Final Product/Process Change Notification

Document #:FPCN24080X

Title of Change:	Alternate die source and MFP-4L conversion to halide-free mold compound.		
Proposed First Ship date:	17 Nov 2021 or earlier if approved by customer		
Contact Information:	Contact your local ON Semiconductor Sales Office or Esther.Lau@onsemi.com		
PCN Samples Contact:	Contact your local ON Semiconductor Sales Office or PCN.samples@onsemi.com . Sample requests are to be submitted no later than 30 days from the date of first notification, Initial PCN or Final PCN, for this change. Samples delivery timing will be subject to request date, sample quantity and special customer packing/label requirements.		
Additional Reliability Data:	Contact your local ON Semiconductor Sales Office or ChangKit.Mok@onsemi.com		
Type of Notification:	This is a Final Product/Process Change Notification (FPCN) sent to customers. FPCNs are issued 90 days prior to implementation of the change. ON Semiconductor will consider this change accepted, unless an inquiry is made in writing within 30 days of delivery of this notice. To do so, contact PCN.Support@onsemi.com

Change table summary:

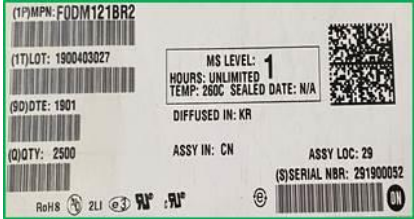
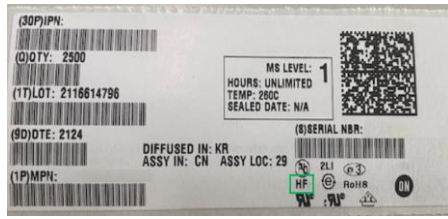
2. Halide-free mold compound for MFP-4L. Refer Table 2 and Table 3 for affected part list.

Item	Before Change (Change From)	After Change (Change To)
1	White: NT-8600A (Supplier N) Black: HC-10-2 (Supplier N)	White: CV1400H (Supplier P) Black: EG200 (Supplier C)
2	MPN label: No HF 	MPN label: Include HF

変更表要約:

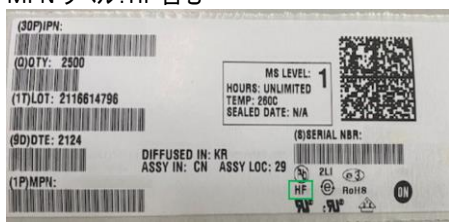
2.MFP-4L 用のハロゲンフリーのモールド樹脂。影響を受ける部品の一覧は、表 2 および表 3 を参照してください。

名称	変更前	変更後
1	白 : NT-8600A (サプライヤ N) 黒 : HC-10-2 (サプライヤ N)	白 : CV1400H (サプライヤ P) 黒 : EG200 (サプライヤ C)
2	MPN ラベル: HF なし 	MPN ラベル: HF 含む
